Applicant:	Horne-Stewart, LLC
Agent:	THE Hensley Engineering Group
Location:	Section 16
Property Size:	Approximately 540 Acres
Existing Zone:	A-1
Proposed Master Plan	Valle del Sol
Recommendation	Denial

AGENDA ITEM NO.: 4
County Planning Commission
April 7, 2010

SPR-70004 The Hensley Engineering Group, agent for Horne-Stewart LLC, requests approval of the Valle Del Sol Master Plan. Valle del Sol Master Plan proposes a planned community for mixed-use residential, commercial and light industrial, including a multi-family housing, parks, trails, and open space. Valle del Sol is located south of the Albuquerque International Airport, north of Mesa del Sol, and east of I-25, within T9N, R3E, Section 16, and containing approximately 540 acres. (Q-15) (DEFERRED FROM THE OCTOBER 7, 2009 HEARING).

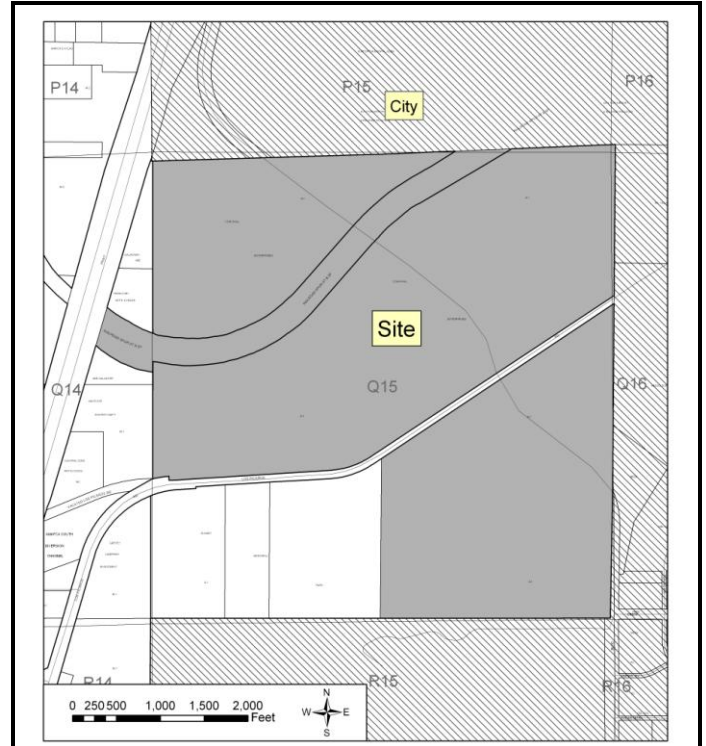
There are several inconsistencies with the vicinity map and land use map and data provided with the application. First, the vicinity map (Figure 1) is of the entire Section 16 (T9N, R3E) in which the subject property is located, which includes the 100 acres in the southwest portion of the property that appears not to be a part of the request. Second, a separate tract of land (the railroad spur) is included in the request but appears not to be owned by the applicant. Third, the land use map (Figure 2) indicates an area of 376.9 acres for the development, while the request is for 540 acres. The applicant must clarify these discrepancies.
